# IAI WESTWIND

## SERVICE BULLETIN

1124 SERVICE BULLETIN INDEX

FIGURE 1A

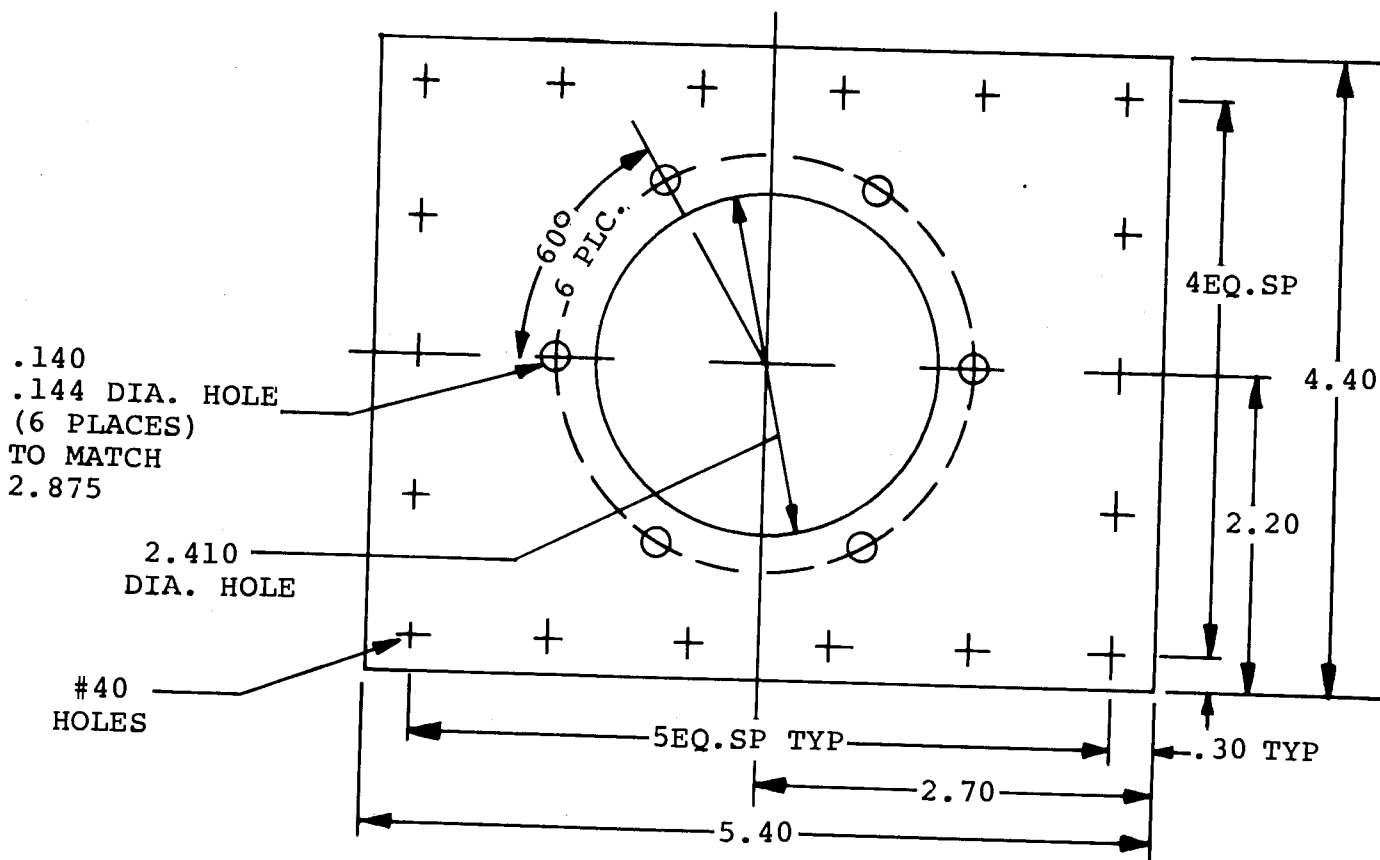
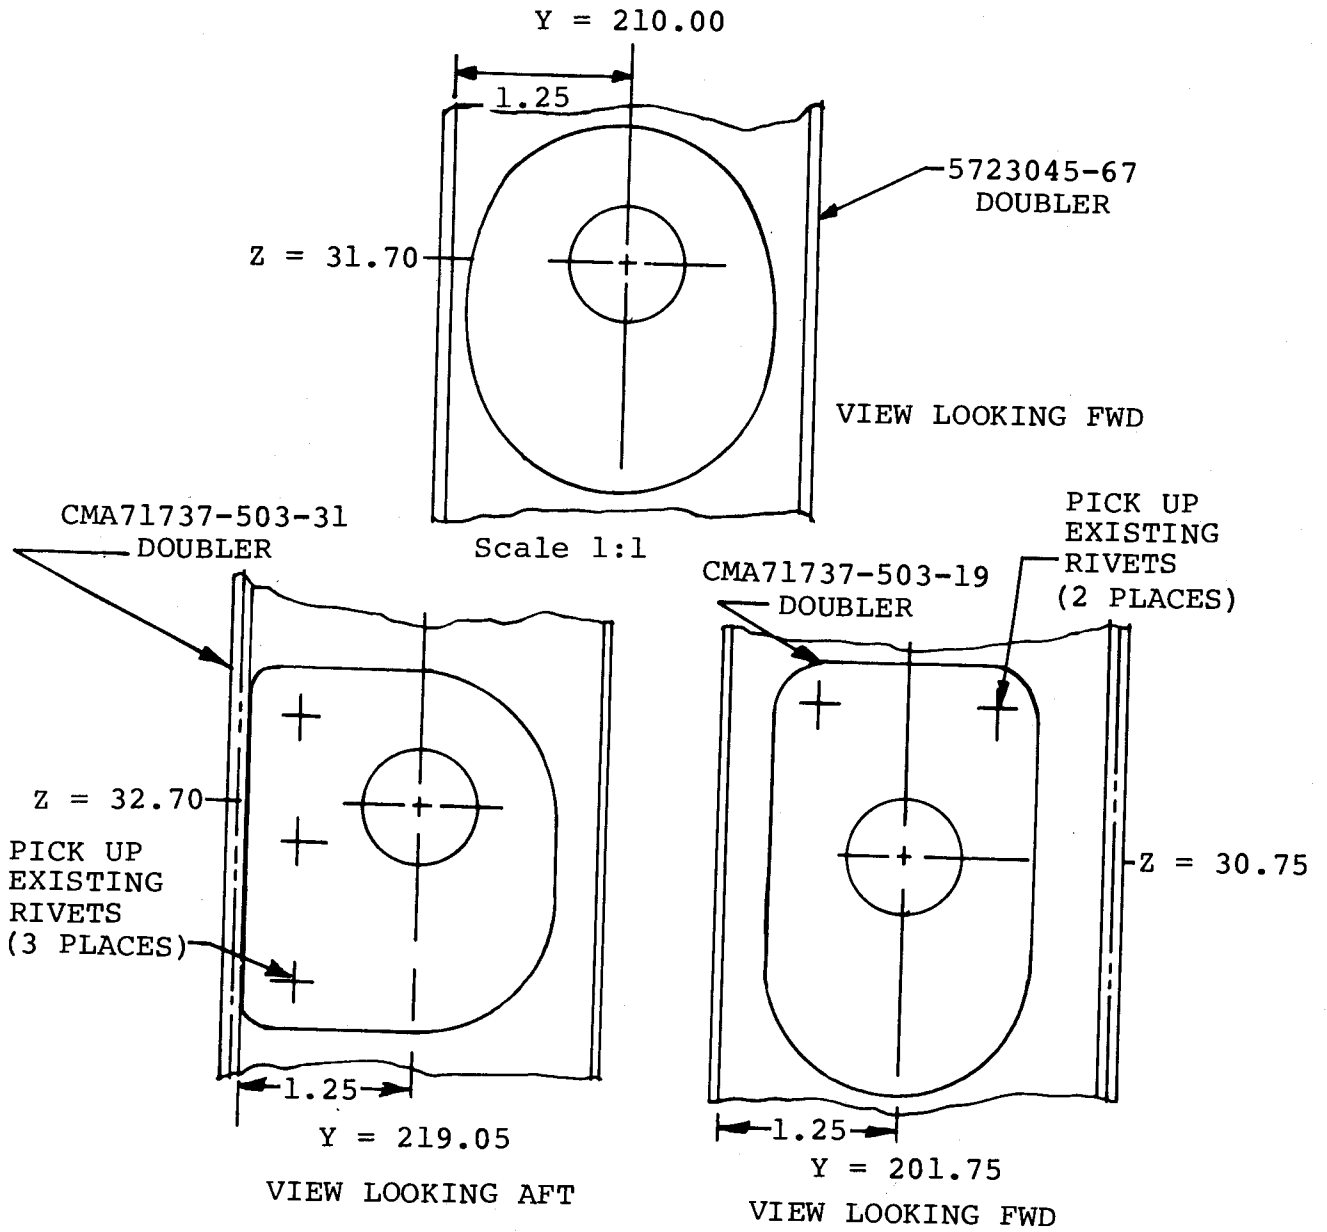
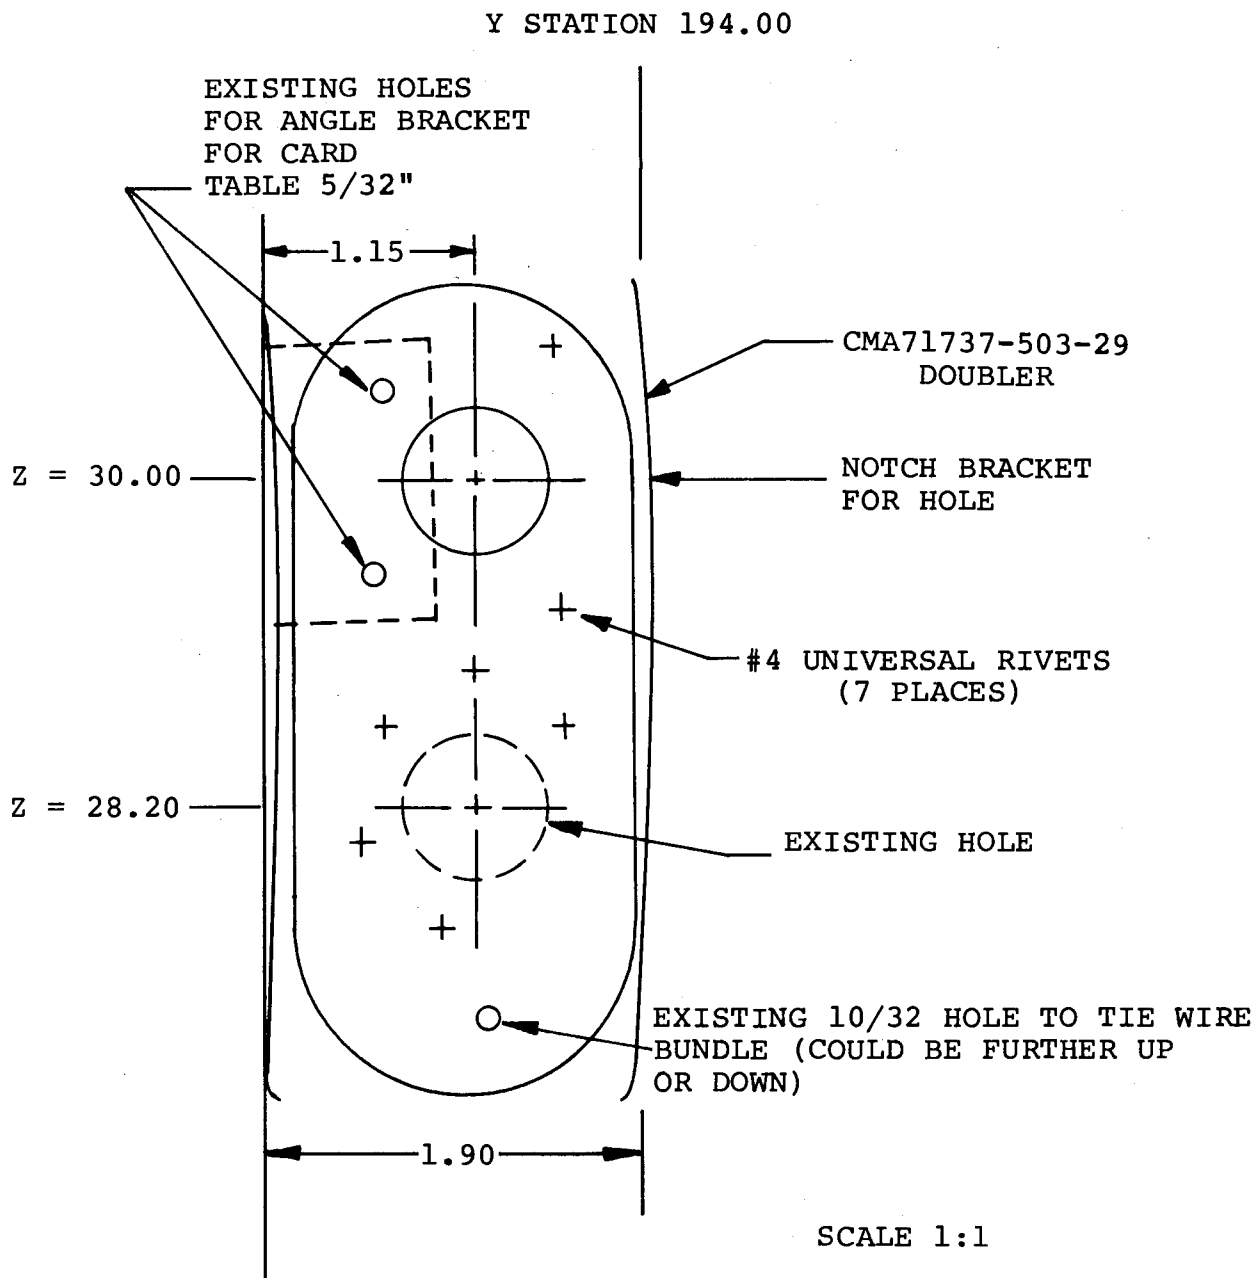
- (1) Remove soundproofing material below R/H emergency hatch, between frames Y-174 and Y-184.
- (2) Locate Y-Station 181 and mark, locate Z-Station 21.70 (water line) and mark. (Refer to Figure 1.)
- (3) Fabricate a doubler (P/N 5723633-51) from 2024-T3 clad .050 thick aluminum as per dimensions in Figure 1A. Etch doubler and treat with Alodine 1201, finish with epoxy primer.

- (4) Measure, mark and cut out hole in fuselage at Y-Station 181 and Z-Station 21.70 (R/H side). Use doubler fabricated above (item 3) as a template for rivet holes and static-port retaining screw holes location (Figure 1).
- (5) Drill .250 inch holes for static-port cover as per dimensions in Figure 1. Attach (2 each) nut-plates P/N NAS1473-1/4-28 and spacers P/N CMA71704-45 to inside fuselage skin.
- (6) Countersink rivet and screw holes for port and doubler from the outside of fuselage skin. Countersink .250 holes for static port cover (Figure 1).

- (b) Doubler for frame 194 must be of sufficient length to cover the existing hole at Z-Station 28.20. (See Figure 1C.)
- (c) Install NAS1033-A3 nut-plate on aft side of frames 210.00 and 201.75 (Fig. 1B). (Same as L/H side.)

- (10) Install static port P/N 4883050 using laminated shim P/N 5723633-53 between port and doubler. Remove laminations from shim as necessary so outside surface of port is flush with outside skin of fuselage + .010 inch. Secure port with AN507-632R10 screws, AN960-06 washers and MS21042-06 nuts (6 each) (Fig. 1).

FIGURE 5

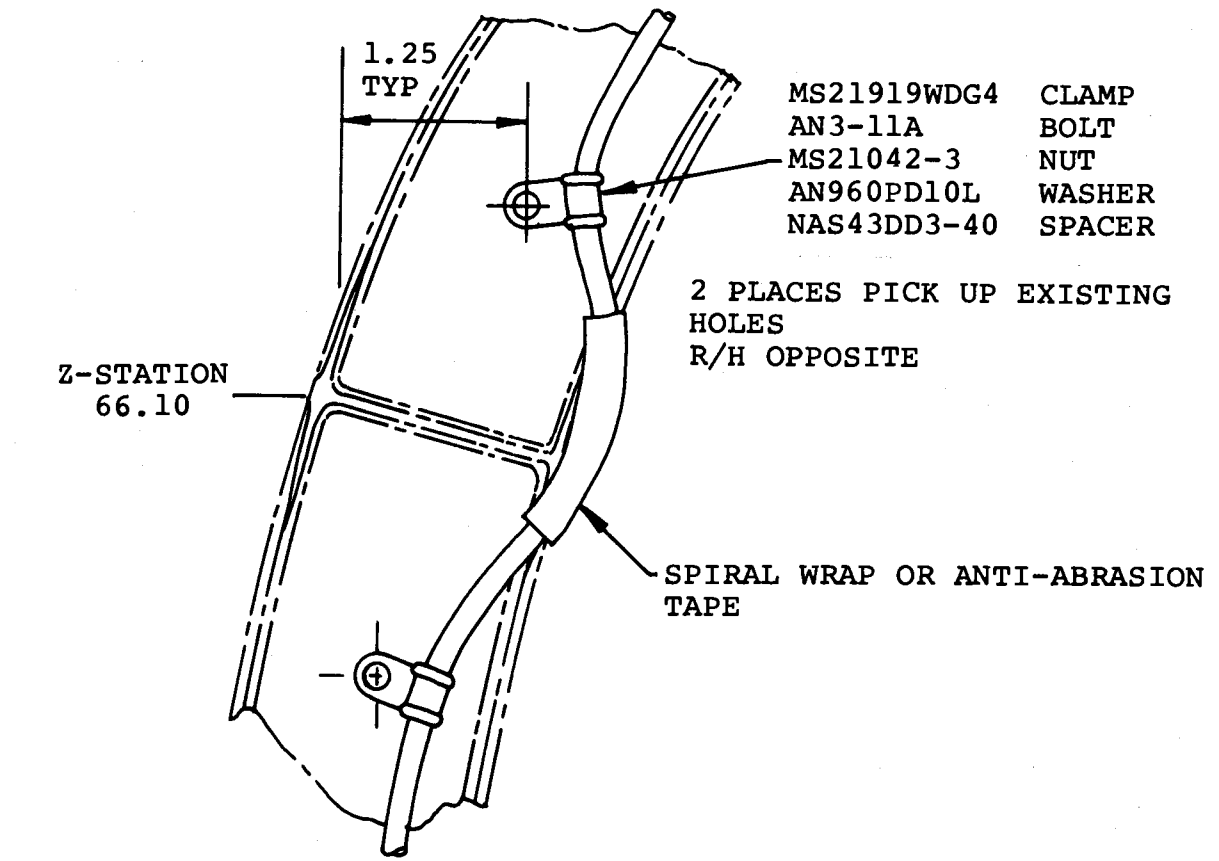
- c. Start at L/H side by routing unflared end of tube up and behind cornice next to frame 219.05. Route tube around channel at Z-Station 66.10 assuring it is routed between channel and conditioned air duct (Fig. 5). Aft most panel of cornice may have to be removed to provide visual access to channel at Z-Station 66.10, both sides. Route tube around R/H channel (Z-66.10) in same manner as L/H side (Fig. 5).
- d. Wrap both sides of tube with anti-abrasion tape or equivalent at Z-Station 66.10.
- e. Attach flared end to L/H union at Z-Station 56.25 (Fig. 3).

Form tube as necessary to support it with the clamping procedure shown in Figure 5. Do not clamp tube until it has been cut and fabricated to proper shape and length.

- f. If bulkhead union is used in R/H channel Z-Station 56.25, cut tube to proper length, attach end fittings (AN819-4D, AN818-4D sleeve and nut) and connect to union. (Support tube as per Figure 5.)
  - g. If bulkhead union is not used, cut tube approximately 2.5 inches above channel (Z-Station 56.25), attach end fittings and connect to a union P/N AN815-4D. (Support tube as per Figure 5.)
- (8) Fabricate a tube from .375 OD X .035W aluminum tubing approximately 2.5 inches in length using 2 each AN819-6D sleeves and AN818-6D nuts.
  - (9) Bend tube approximately 35° - 40°, connect to center port of R/H static port.
  - (10) Install AN919-6D reducer to other end of tube.

POWER SUPPLY INSTALLATION  
FIGURE 1

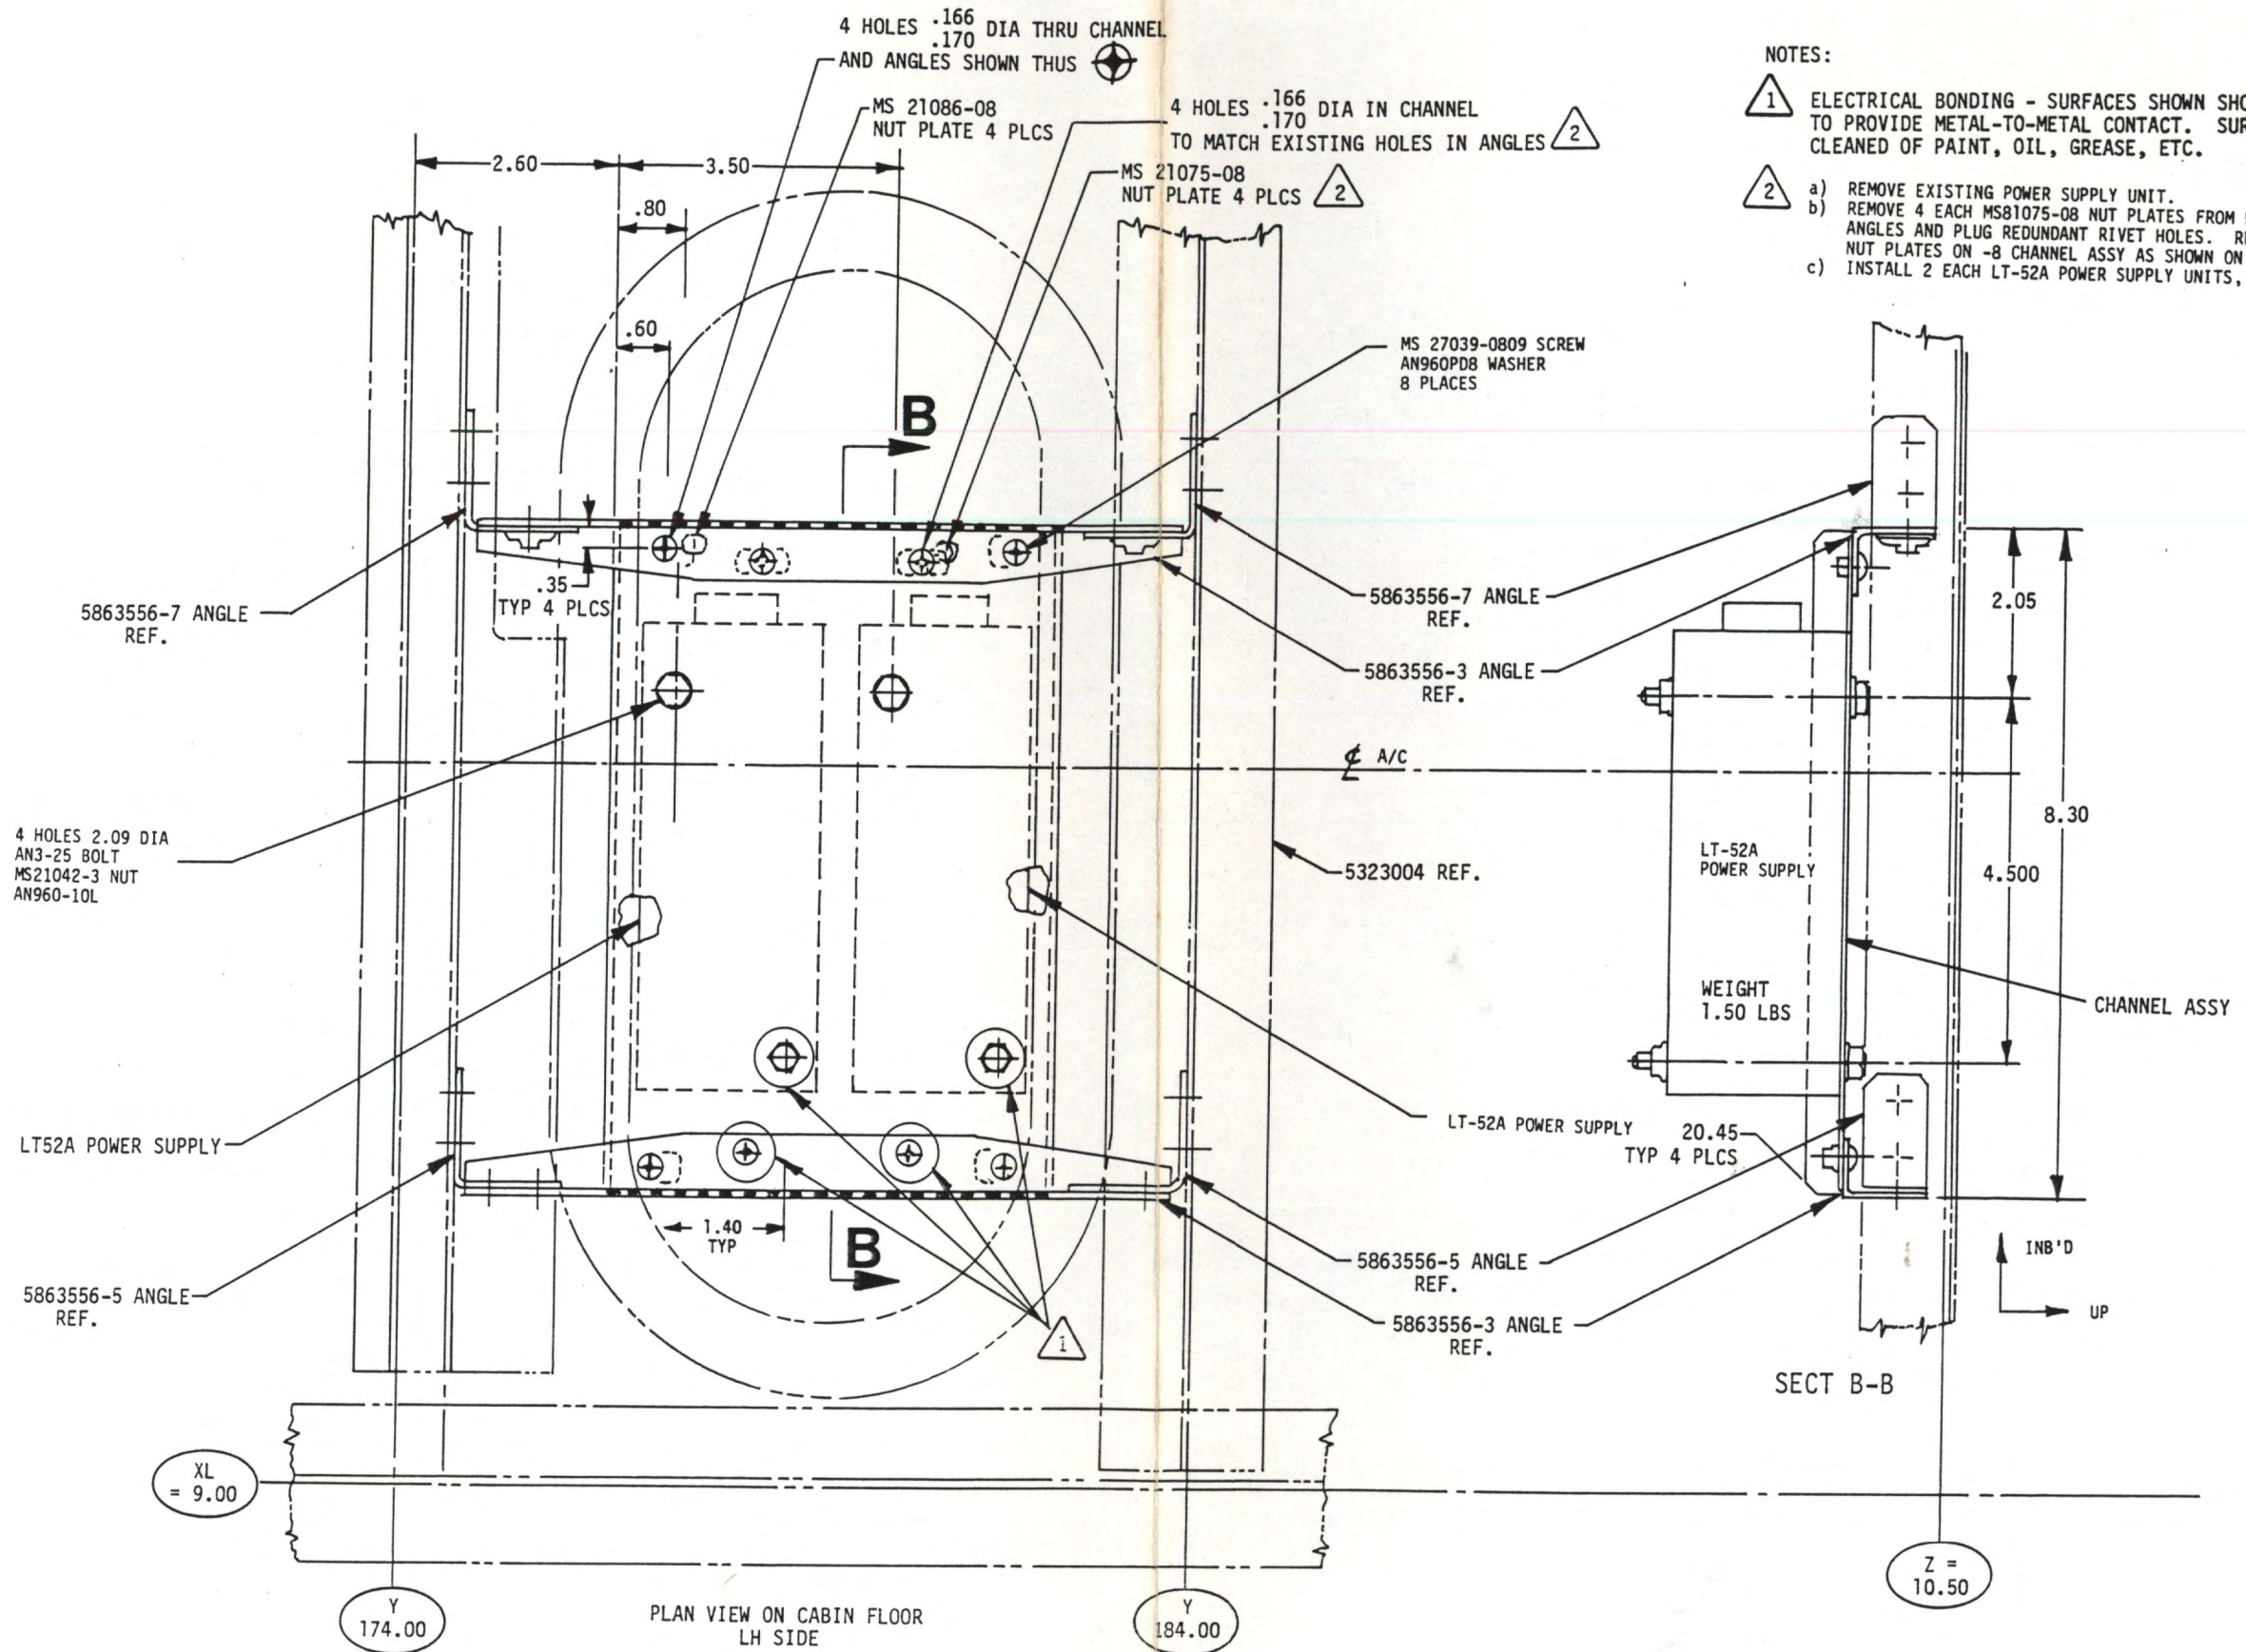
- (3) Modify existing mounting plate angles as shown in Figure #1 to accommodate installation of 2 each KGS LT-52A power supplies and new plate P/N 5863569-3. Install power supplies with AN3-25 bolts.

- (4) Install mount and power supplies to airframe using existing angles and hardware shown on Figure #1 to mount new plate. Label power supplies as B206 and B211 for reference and identification purposes.
